Urgent Field Safety Notice

794400008

XQ series: Incorrect WBC result output to the host computer

Product Name	XQ-320; XQ-520
Product Description	XQ-Series Automated Hematology Analyzer
Affected Serial No	all
Type of Action	Advice given by manufacturer regarding use of the IVD
FSCA-identifier	794400008

Figure 2: Example screenshot of affected settings – the issue does occur.

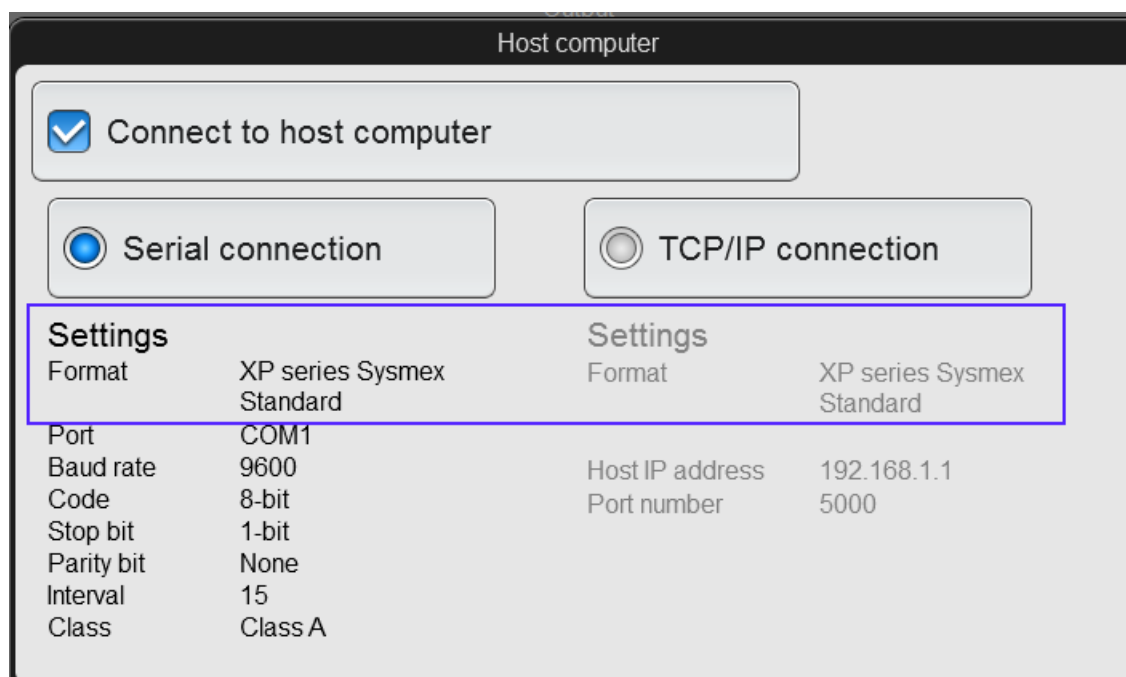
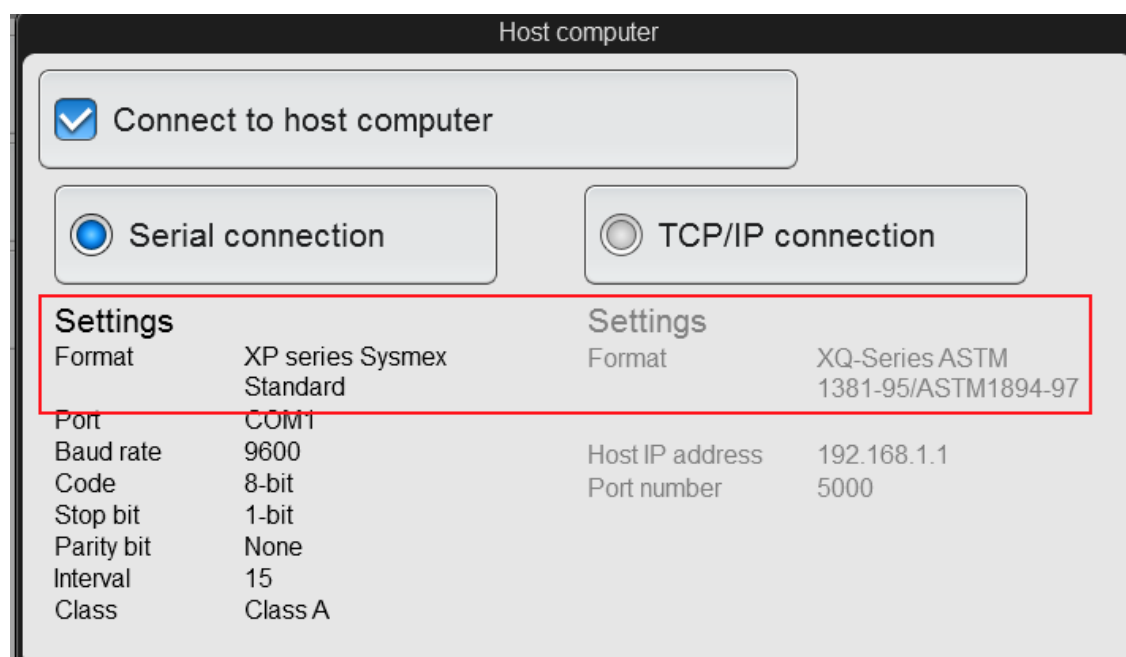
WBC value results transmitted from the analyser to a host computer are 10 times higher than the correct results displayed on the analyser screen.

This malfunction occurs only when you use a serial connection and a legacy data transfer format (KX21N or XP series standard) and is caused by the **[Serial connection]** and **[TCP/IP connection]** settings not matching. Due to a software bug, the host format setting selected for TCP/IP is used, even when a serial connection is used.

1. Confirm whether the WBC results in the analyser software and in the LIS on the host computer match.
2. If WBC results do not match, that is, if WBC results on the host computers are higher by a factor of 10, change the host computer setting. The data format of **[TCP/IP connection]** must be the same as the data format of [Serial connection].
